PLANNING & ZONING COMMISSION
MEETING
SAMUEL E. DEAN BOARD ROOM
BUTLER GOVERNMENT CENTER
1200 OAK BROOK ROAD
OAK BROOK, ILLINOIS
630-368-5000

Regular Meeting
Wednesday, October 2, 2024
6:30 PM

SUBDIVISION AMENDMENT **3601 & 3505 ADAMS**

DESCRIPTION: Subdivision Amendment L2KM2 Subdivision – 7.64 acres – Final Plat

PROPERTY ADDRESS: **3601 & 3505 ADAMS ROAD
OAKBROOK, ILLINOIS**

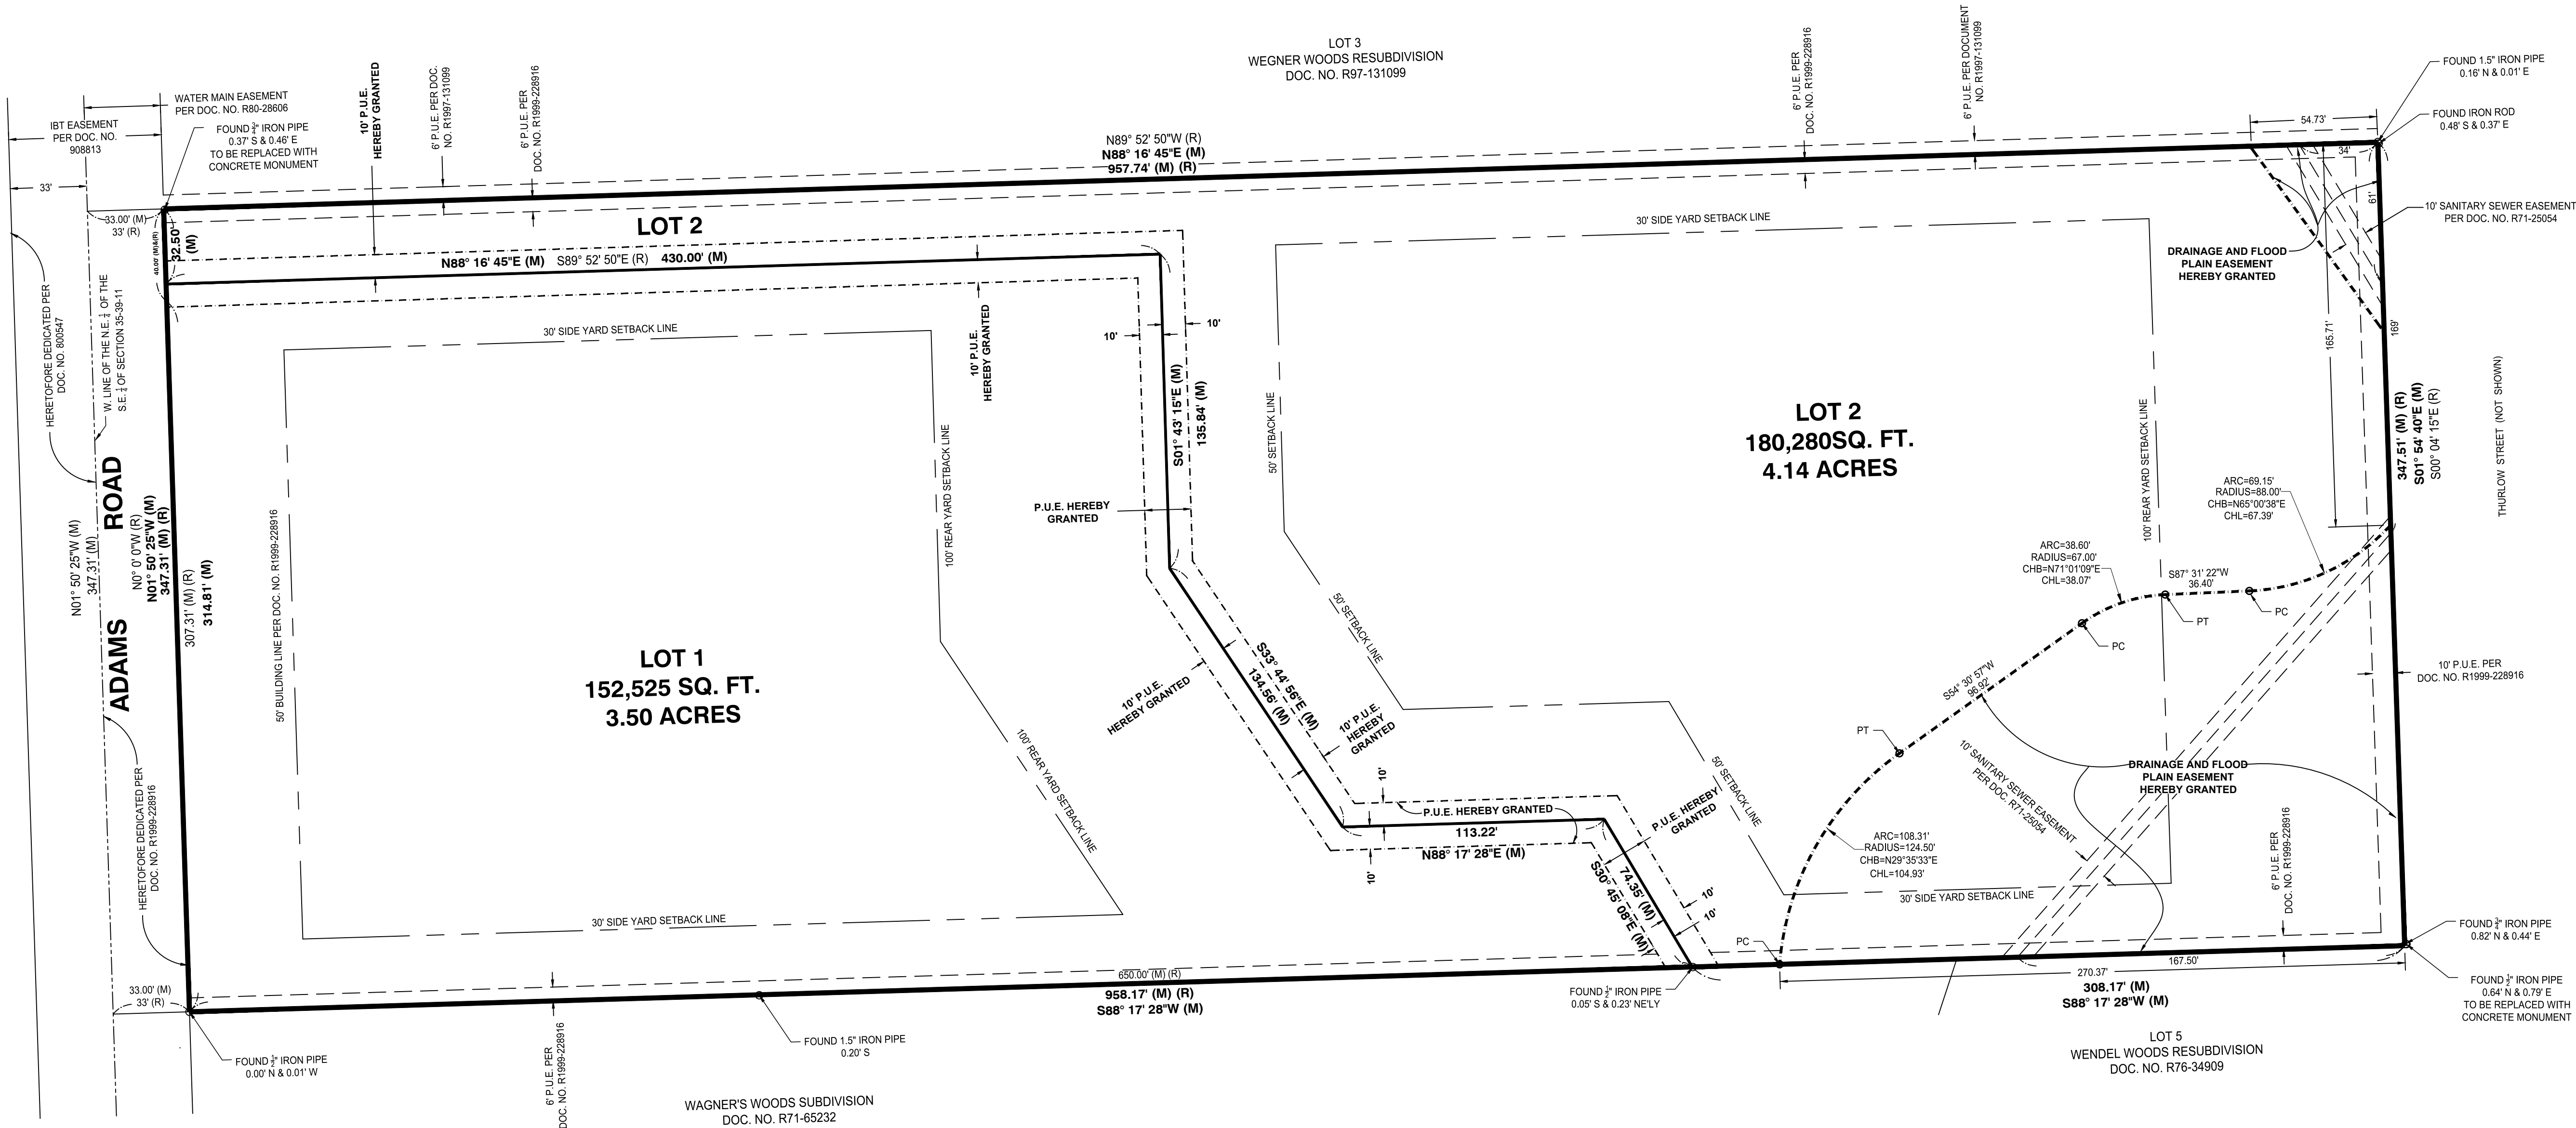
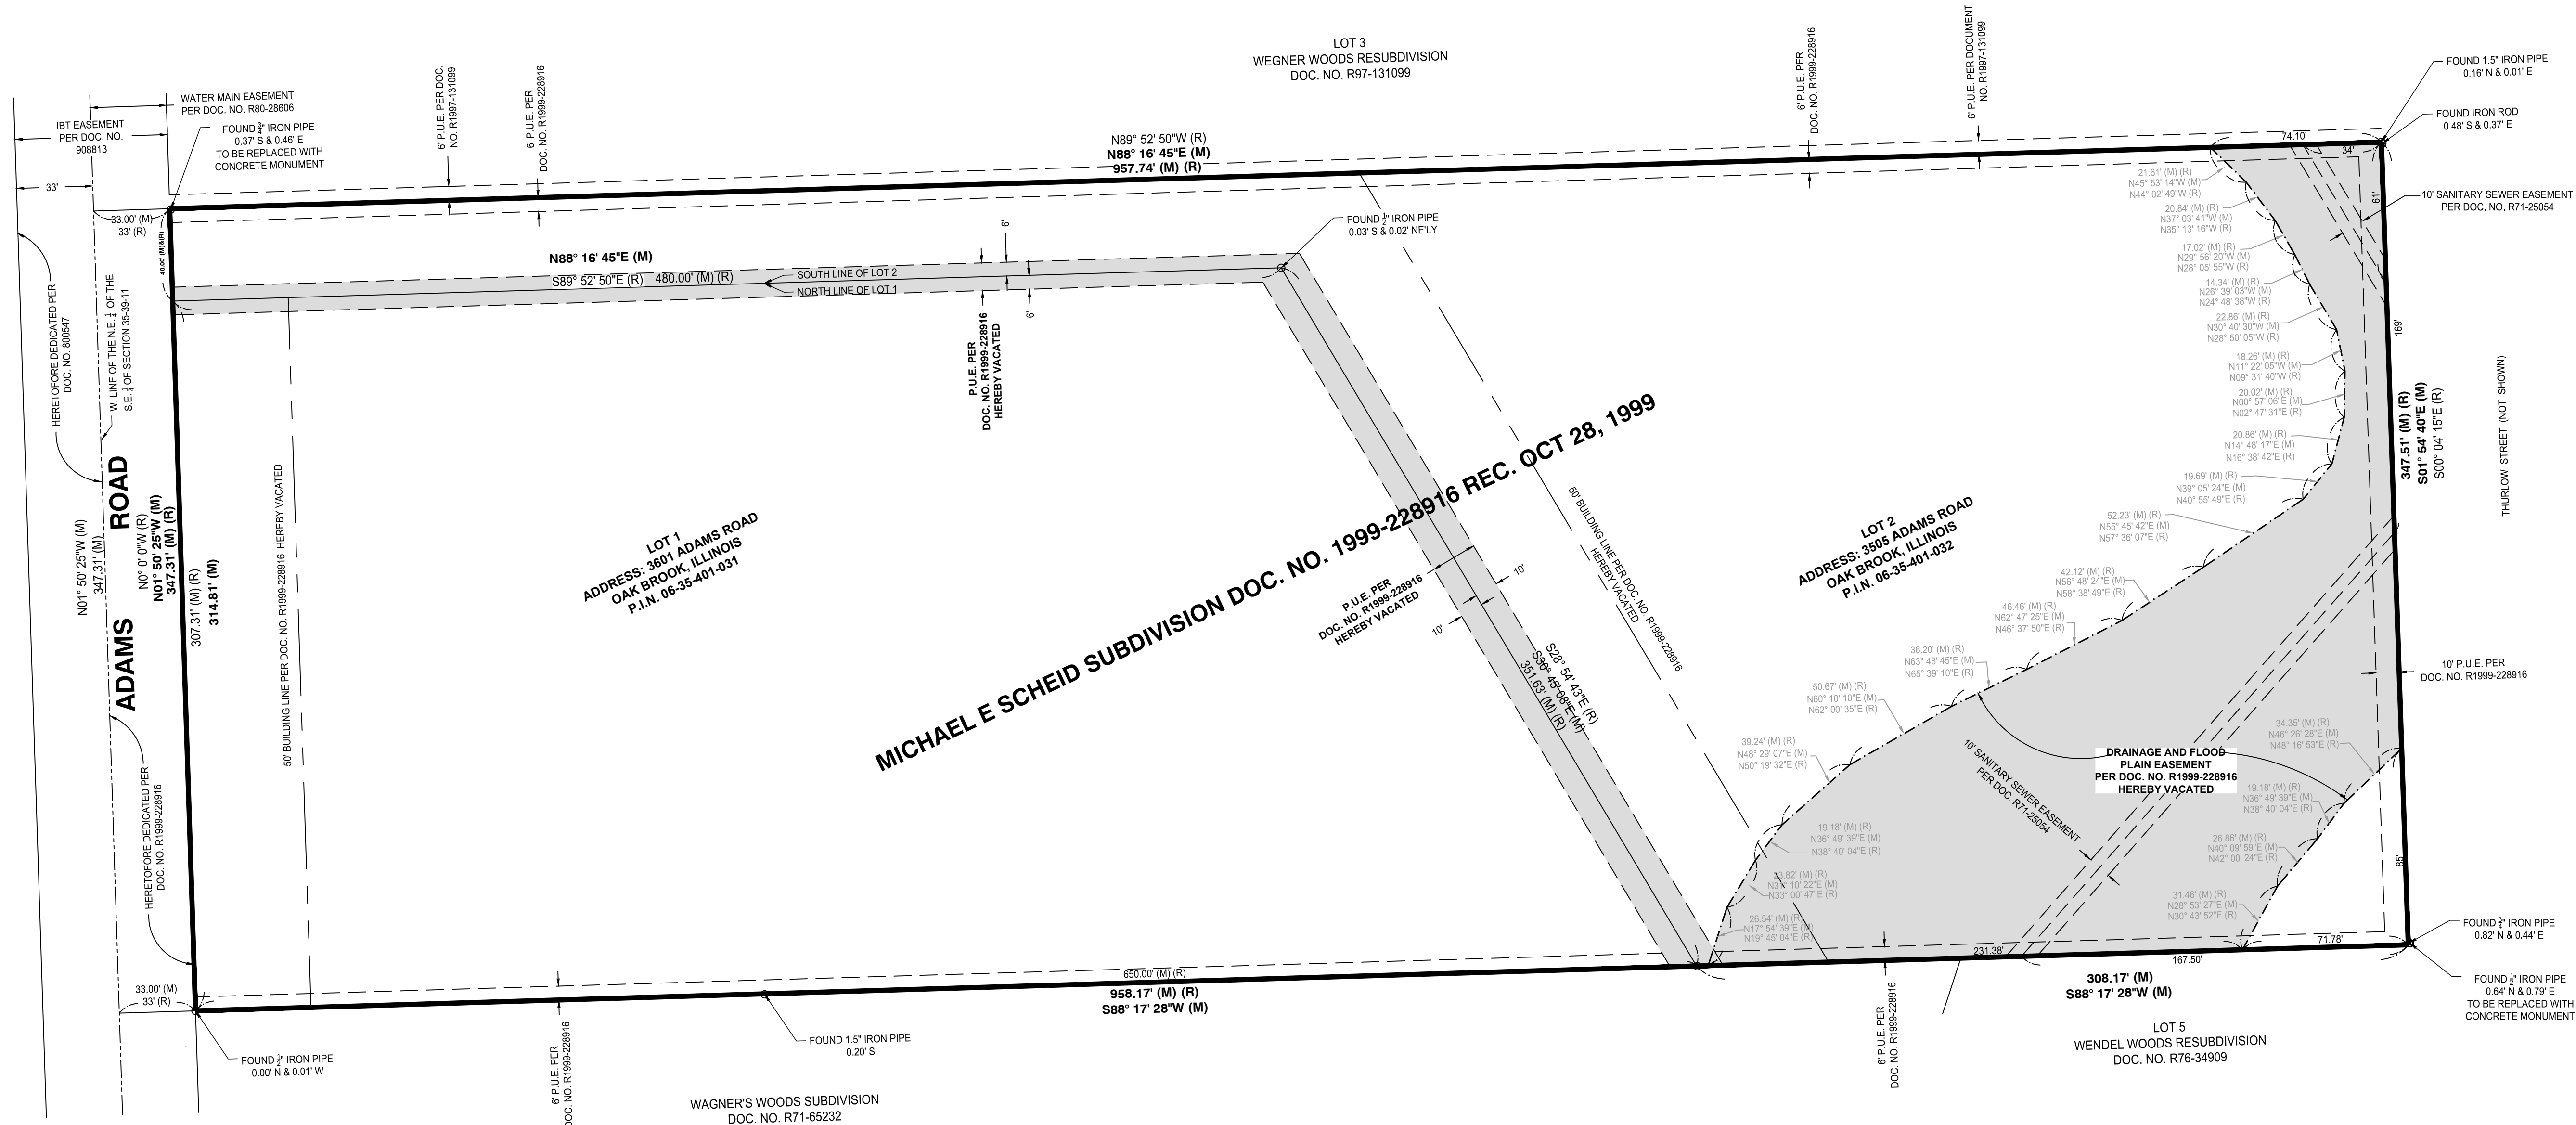
5. Title 14-4-2.B.1 – Include the term **FINAL PLAT** in the title of the document.
6. Title 14-4-2.B.2 – Provide a full and detailed description of the land embraced in the plat. This can be the same as the legal description provided in the Surveyor's Certificate.
7. Title 14-4-2.C.2 – Revise the font (size, bold) along the south property line of Lot 1 for consistency with the rest of the plat. Generally, the dimensions and bearings of the proposed lots are bold. The existing lots are not.

8. Title 14-4-2.C.2 (and 14-6-2.B.8) – Update the limits of the Drainage and Floodplain Easement recorded under Doc. No. R1999-228916 in accordance with the updated floodplain limits (see comment #2 above). The same easement provisions can be used on this plat.

9. Title 14-4-2.C.2 – An existing 20' Public Utility Easement (centered on the shared property line between existing Lot 1 and Lot 2) shall be vacated. Grant a proposed 20' Public Utility Easement (centered on the proposed shared property line between proposed Lot 1 and Lot 2). Please note that a concept plan provided to Village staff for detention waiver purposes showed a proposed residence within the existing easement.

12. Title 14-4-2.D.2 – Remove the second Notary's Certificate from sheet 2 (lower left corner).
13. Title 14-4-2.D.3 – Update the Land Surveyor license number (no. 4071) for Jianfeng Hua, PLS. The certificate references surveyor no. 2580. Please note the surveyor's seal shall be placed adjacent to the certificate prior to recording.

14. Title 14-4-2.D.8 – Revise the title of this Certificate to **PLANNING & ZONING COMMISSION CERTIFICATE**. The certificate language shall be revised to read, "APPROVED BY THE **PLANNING & ZONING COMMISSION** OF THE VILLAGE OF OAK BROOK..."
